SS 781-WST Western Star vehicles with excessive water intrusion into the air system.

New Western Star 47x, 49x all builds.

Vehicles with excessive water intrusion into the air system.

WAB434 100 310 0

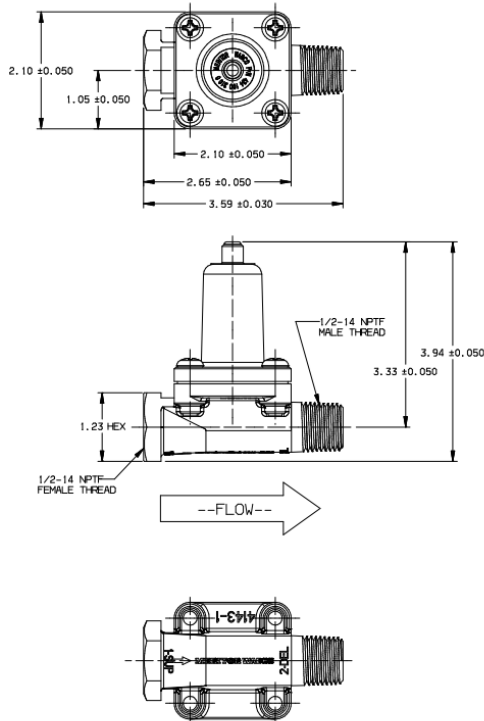
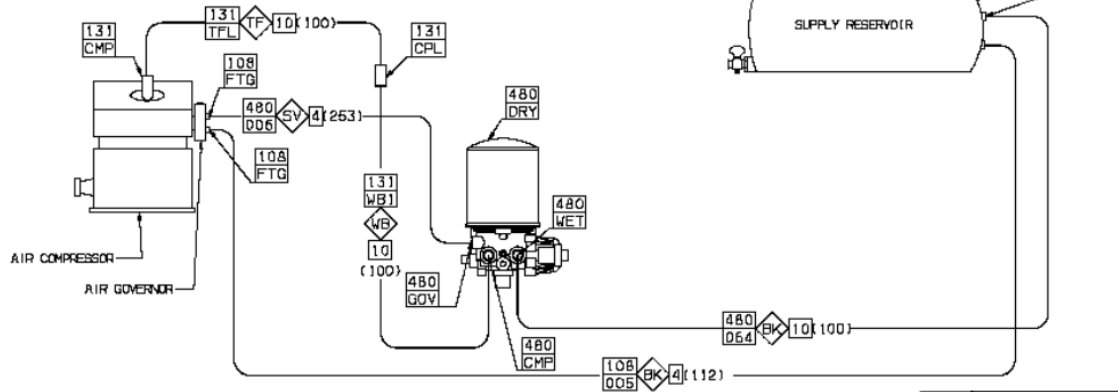
1. Ensure that the Pressure Controlled Check Valve (PCCV) is correctly installed. REF: module-871 for the relevant install to the vehicle.

1. **PRESSURE CONTROL CHECK VALVE (PCCV)**
REPLACES THE STANDARD CHECK VALVE.
2. EXACT PIPING MAY VARY. SEE INDIVIDUAL
MODULES FOR APPLICABLE DIAGRAMS

INSTL-PP,DISCH,INSULATION,WB2

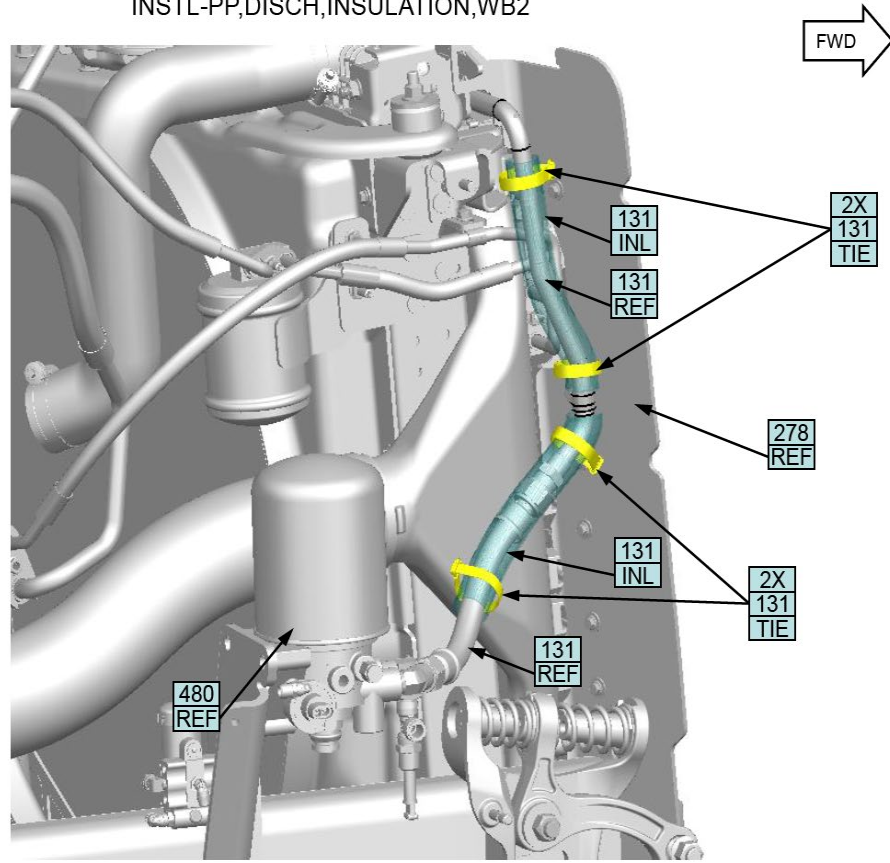
2. For vehicles with lower expected duty cycle of air system, replace existing Wabco SS1200 dryer and add discharge line insulation per 131-D70100.

Example BOC air dryer spec: 480-C16780 - WABCO HP W/OC LHIB

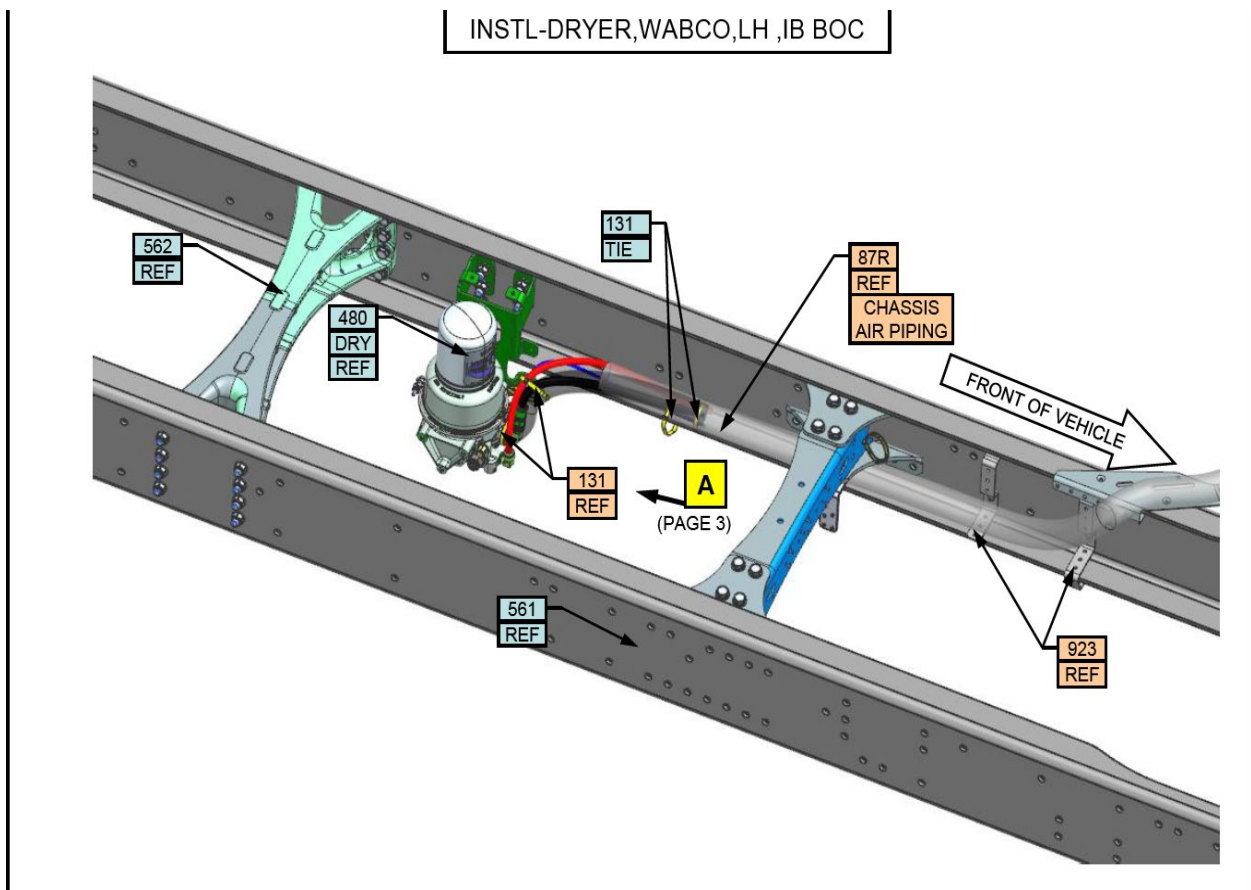
3. For vehicles with higher expected duty cycle of air system, remove existing Wabco SS1200 air dryer and related discharge line and replace with either Wabco HP dryer or Bendix AD9si back-of-cab and route new discharge line.
